Source: Tłįchǫ Government **To:** De Beers Canada Inc.

Subject: Socio-economic Commitments by the Developer and Contractors

EIS Section: Chapter 12 pp. 107, 243

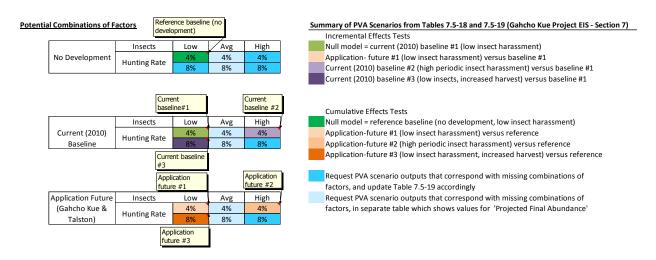
47.1: We request the PVA scenario outputs that correspond with the missing combinations of factors highlighted by the bright blue cells (in the table below) along with an updated version of Table 7.5-19

- Please provide an additional column titled 'Projected Final Population Abundance' with corresponding values for total population size that includes males and females.
- 47.2: We request PVA scenario outputs that correspond with the missing combinations of factors highlighted by the light blue cells in a separate table which shows values for 'Projected Final Abundance'.
